Bylaw 20319

A Bylaw to amend Bylaw 17270, as amended,
being the Riverview Neighbourhood 3 Neighbourhood Structure Plan

**Bylaw 20319
Amendment to
River's Edge
Neighbourhood Structure Plan
(as amended)**

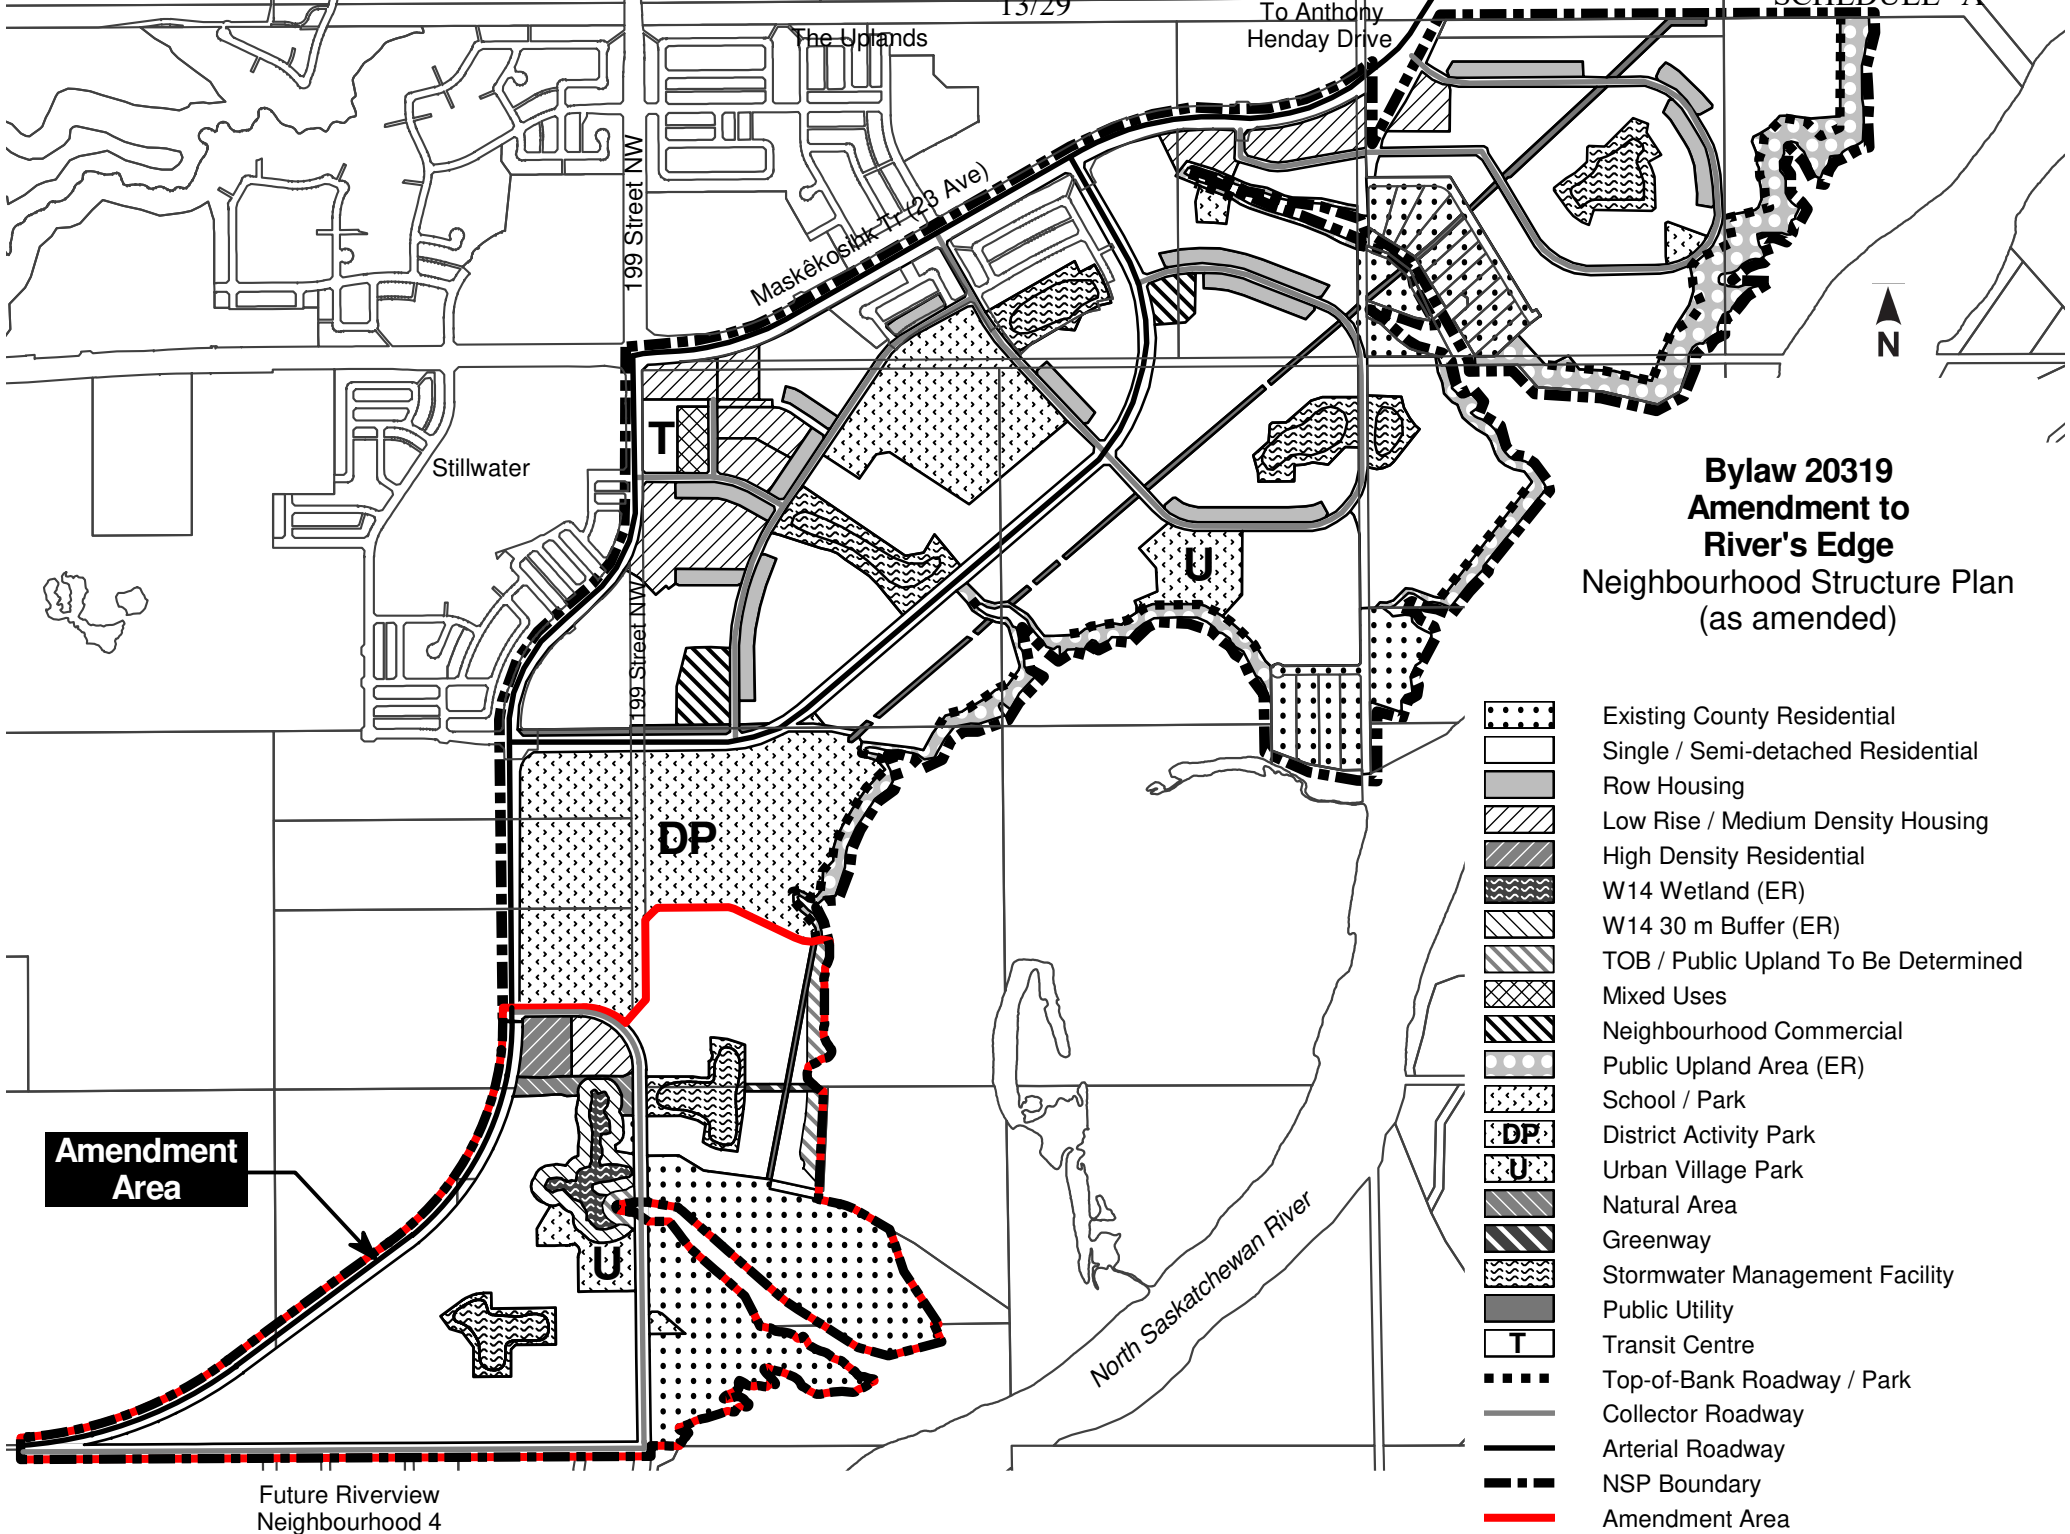
- bbb. Following the table of contents, adding the map entitled “Bylaw 20319 – Amendment to River’s Edge Neighbourhood Structure Plan”, attached hereto as Schedule “A” and forming part of this bylaw;
